# Village of Lincolnwood Plan Commission

# Plan Commission Staff Report

6733-6735 North Lincoln Avenue

# PRELIMINARY ENGINEERING PLAN FOR 3 STORY MULTI USE STRUCTURE 6733 LINCOLN AVE. LINCOLNWOOD, COOK COUNTY, IL

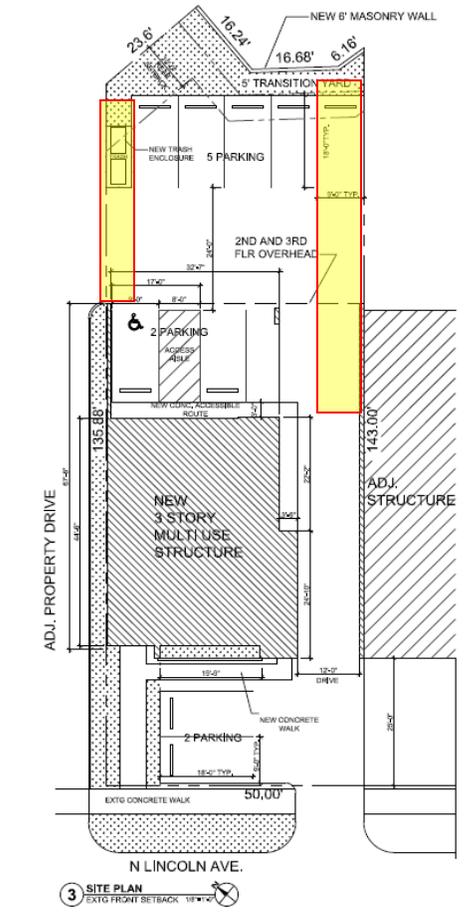
Off-Street Parking Perimeter Landscape Variation: The Petitioner seeks approval to permit the perimeter landscape setback along the north and south lot line of the rear off-street parking area to not meet the minimum width of eight feet. The new off-street parking area does not include any perimeter landscape area.

The area highlighted to the left on the site plan identifies the location of the requested variation to permit less than the required eight-foot perimeter landscape area and screening. The proposed parking area does not include the Zoning Code required screening that is planted within the perimeter landscape area as per Section 6.14(1)b.

Two (handicap space + one space) of the seven total spaces are not subject to this regulation as they are located below the second and third floor of the proposed mixed use building.

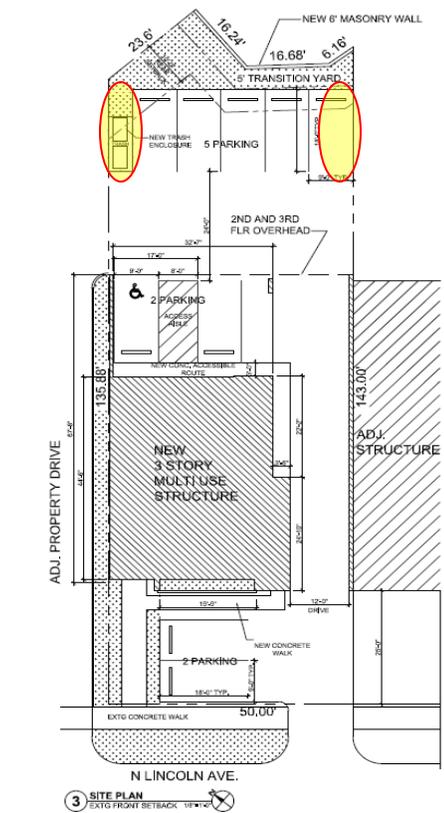
The Petitioner seeks relief from the minimum interior landscape requirements of the Zoning Code. The highlighted areas of the site plan to the right represent the locations of required landscape islands at the end of the row of parking.

The highlighted area at the north of the property is a landscape area in which is a proposed dumpster. At the south end of this parking row no landscape island is proposed.

Landscape islands are to be 9' x 20' and include one tree. The Petitioner seeks approval to include no

Zoning Code compliant landscape islands at the end of the parking row.

**PROPOSED, GEOMETRIC, GRADING,  
 DRAINAGE & UTILITY PLAN**  
 3 STORY MULTI USE BUILDING  
 6733 LINCOLN AVE., LINCOLNWOOD, ILLINOIS

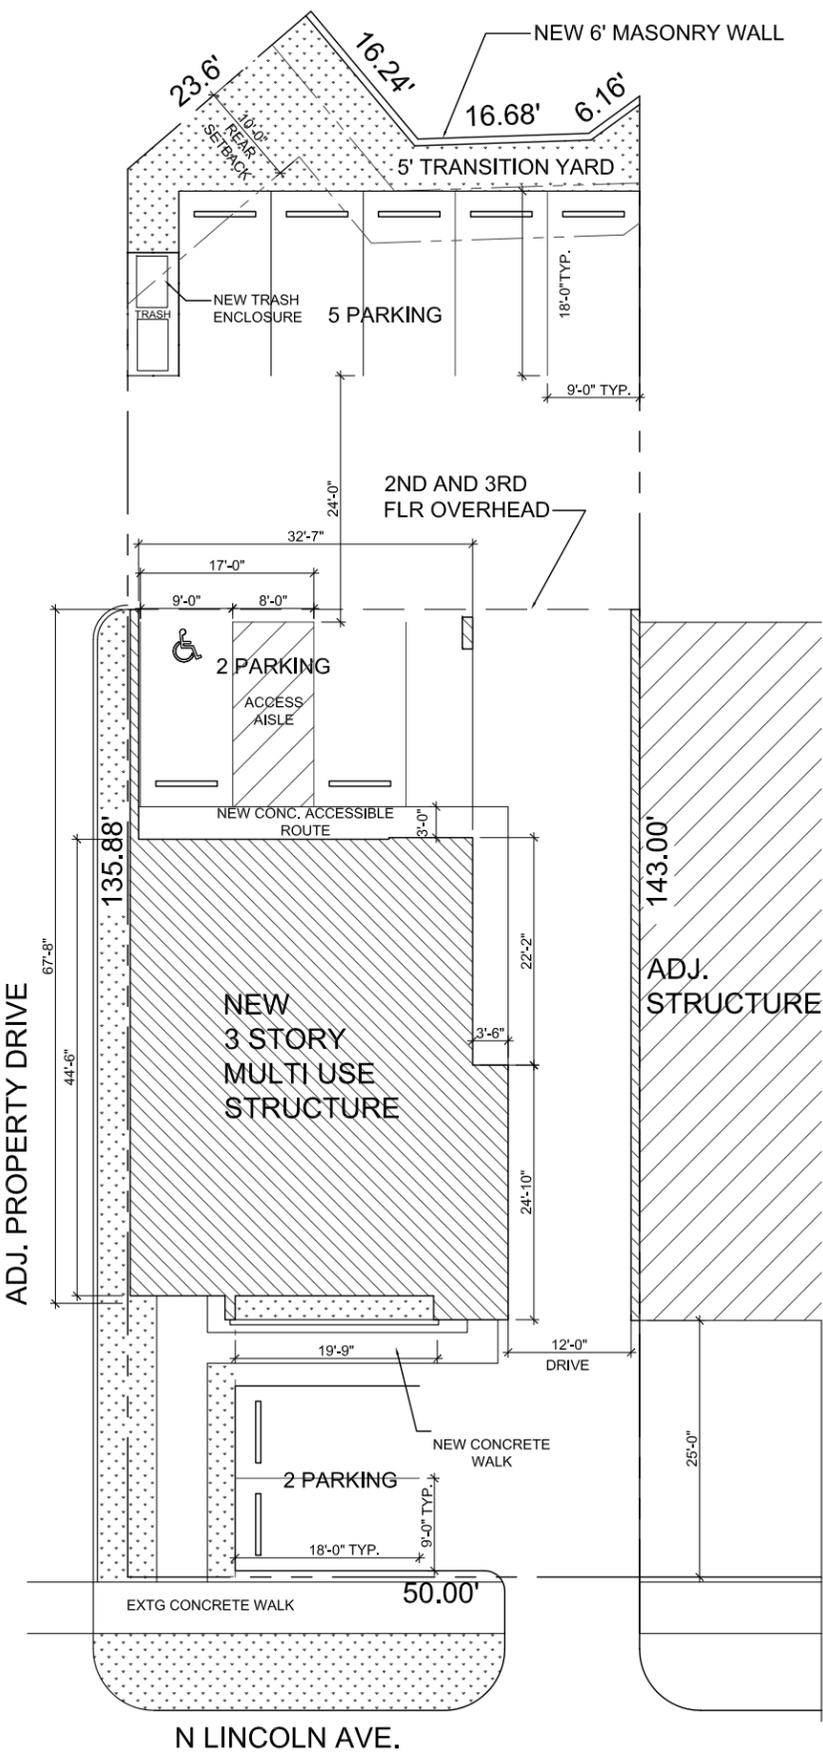
- All utilities must be buried underground.
- The proposed two inch water service may be inadequate to provide required fire flow. The domestic and fire service lines need to be split outside of the building.

- There appears to be inadequate height to bring a semi-tractor through to the rear of the building. The owner should clarify what size delivery vehicles will service the building.

- The site is 7107 SF (0.163 Acres) in area. As such it does not have to provide detention or retention per the MWRDGC WMO, but is required to provide detention under the Village's stricter ordinance. Using the NIPC detention volume nomograph, this site would need to provide 3485 CF (0.08 Acre-feet) of detention storage. This can be provided in several ways and combinations: permeable pavement with underlying stone storage field, construction of underground detention in pipes or cisterns, or surface storage in the parking lot. An alternate could also involve varying some or all the detention requirement to replace it with a green roof. The developer is already providing for a social space on the roof with perimeter shrubs. Further green areas could be added to enhance the ambiance of the social area while providing a stormwater benefit.

- We recommend curbing all open sides of the rear yard landscape area to protect the plantings from errant vehicles from the adjoining properties. The curbing would eliminate the need to install parking bumpers for the rear stalls.

- The final engineering plans shall indicate the abandonment of the existing sanitary and water service. As the existing water service is most likely connected along Lincoln Avenue, it would be advisable to have the new service connection as close as possible to the old one so that only one excavation in the roadway is necessary.

- If the building is to be sprinkled, the proposed two inch service may be inadequate to provide the required fire flow. If a fire suppression system is required, then the

- We note that there is only a 10 foot vertical clearance for the drive thru the building to the rear parking area. There is no defined loading zone for the site, but the larger double doors are located at the rear of the building. There is inadequate height to bring a semi-tractor through the building. The owner should clarify what size delivery vehicles they intend to have service their building **and/or if they intend to unload their vehicles while parking on Lincoln Avenue.**

- A turning exhibit should be provided for the specified delivery vehicle to show it can enter and leave the site.
- Again noting the 10 foot vertical clearance, we will defer to the judgement Fire Department to determine if there is adequate access to the rear of the building through the adjacent properties.

- Given that the proposed development is not providing all of the required parking stalls for itself, the likelihood that the parking lot will be filled is high. Concurrently, we have concerns that several of the parking stalls will be hard to access or leave from without multiple point turns. The engineer should provide turning exhibits showing how passenger cars will enter and exit from both the front and rear parking stalls, both with and without adjacent stalls being occupied.

- No existing or proposed topographic elevations are shown on the submitted plans. The final engineering submittal shall include all existing and proposed site grading.

- The final engineering submittal shall include the locations of all proposed downspouts. Given the close proximity of the adjacent buildings, the discharge location of the downspouts should be fixed so that it minimizes risk to these buildings. One potential discharge location would be to run it to the rear yard landscape area and allow it to disperse there with a pop up emitter to water the proposed plantings.
- The final engineering submittal shall include all applicable pavement and utility standard details and specifications.

LANDSCAPING PLANS

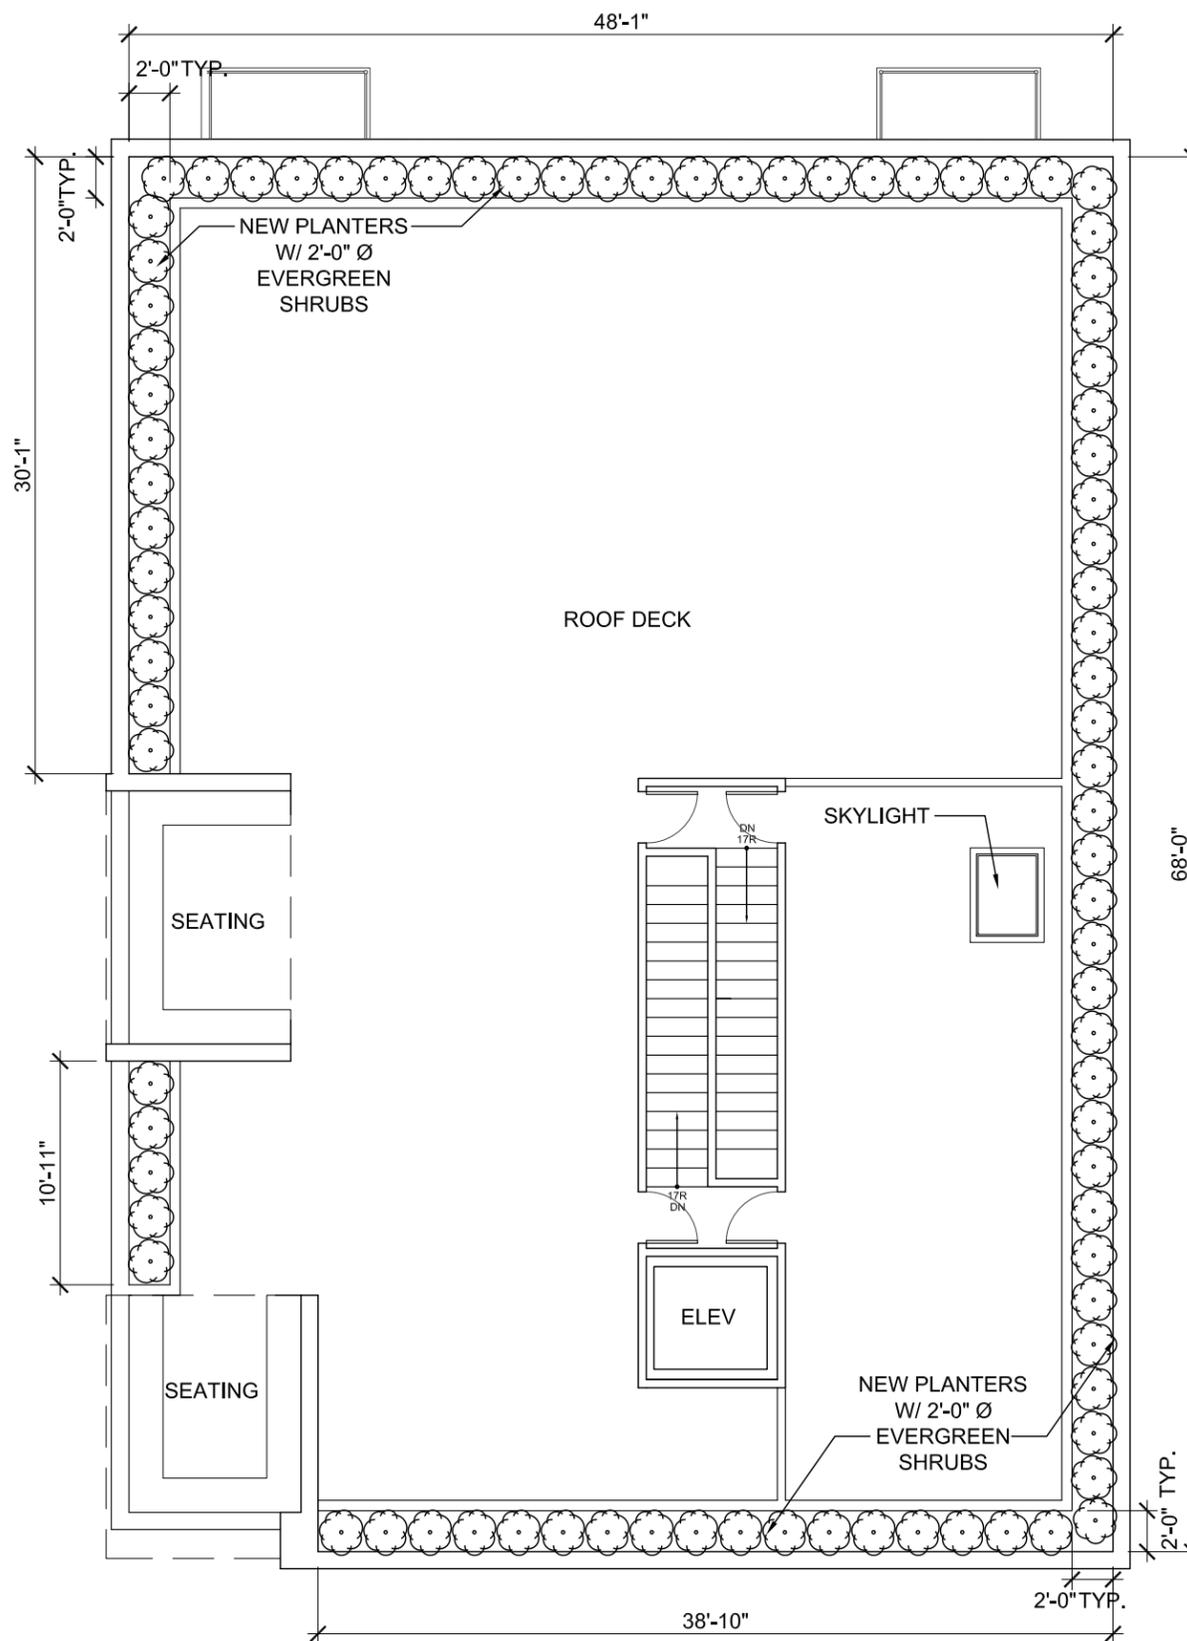
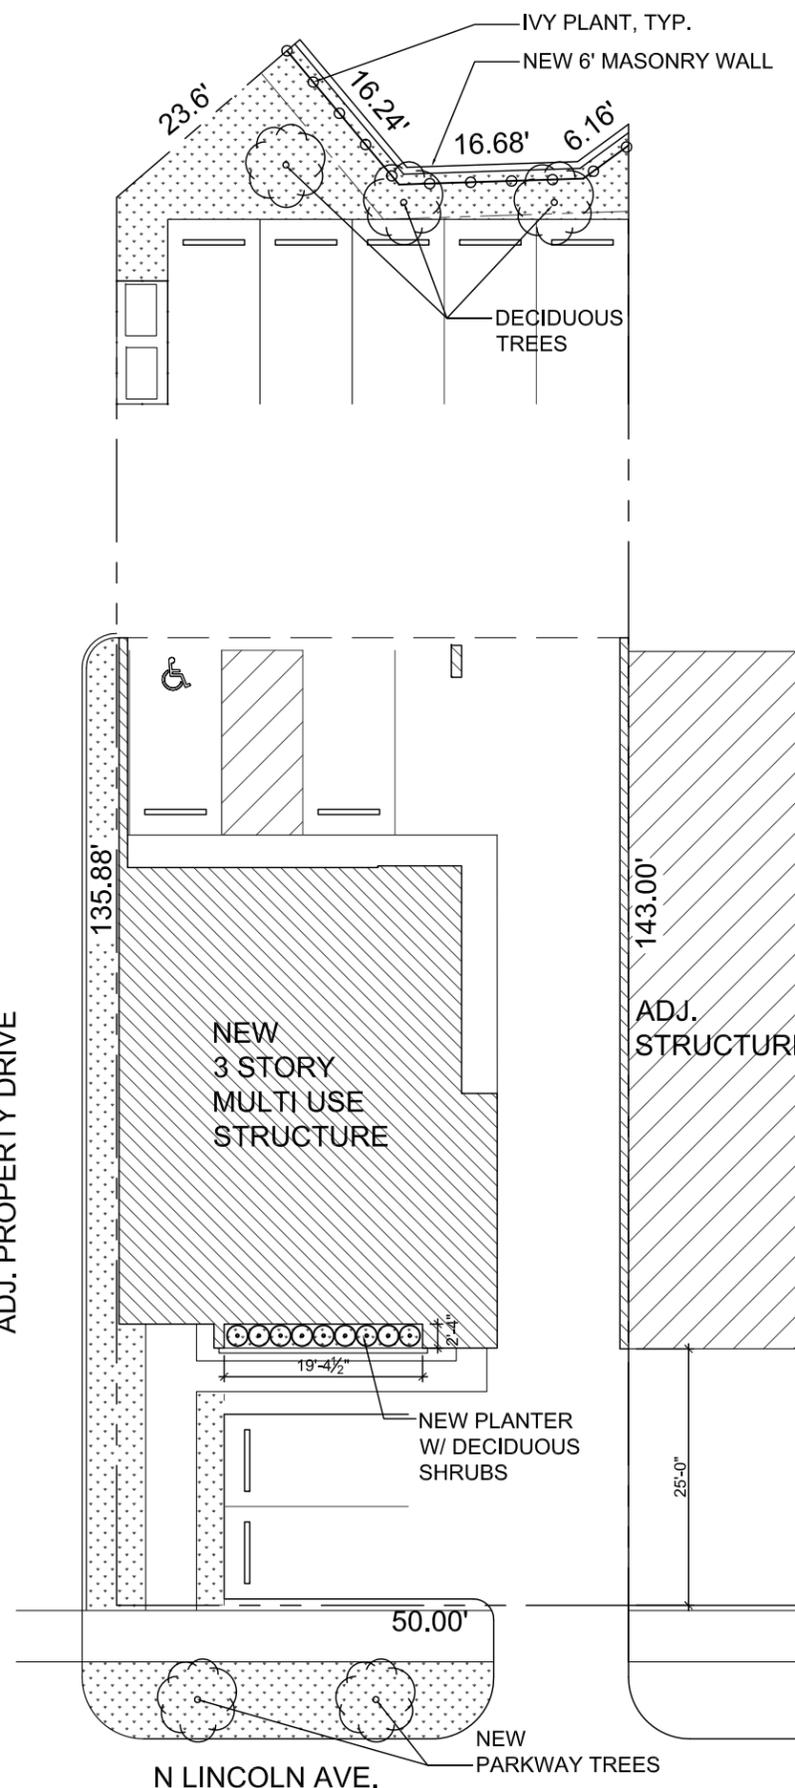
- Replace the existing public sidewalk adjacent to the property, which is currently in poor condition. This sidewalk must be five feet wide.
- There is a concern with the success and long term viability of the rooftop planter areas shown at the perimeter of the building.

- A schematic plan was provided with the review documents but an actual landscape plan was not submitted.
- A trash enclosure is indicated but no details to its height or appearance is given.

- No site lighting has been indicated at this time.
- An estimated cost for the landscaping was not provided.
- The current site plan with the indicated screen wall does **not** meet the requirement of a minimum of 5' width **perimeter** landscape buffer.

- The preliminary site/landscape plan does not illustrate and separation curb from the drive aisles and parking surfaces.
- The current site plan does not meet the requirement for a six feet wide landscape setback along the front and sides.

- As a part of the landscape plan a perimeter roof top planter is shown. Over the years I have observed many attempts at installing woody plant material in above grade planters and the majority of them fail. Usually this is due to lack of water, lack of nutrients, poor drainage, and severity of the winter or poor plant material selection. It will be important that roof top planter have a support irrigation system, seasonal fertilization plan, adequate drainage for the soil and plant material selected to survive in a USDA plant hardiness zone higher than Lincolnwood.

- A full landscape plan for the project needs to be submitted for review.
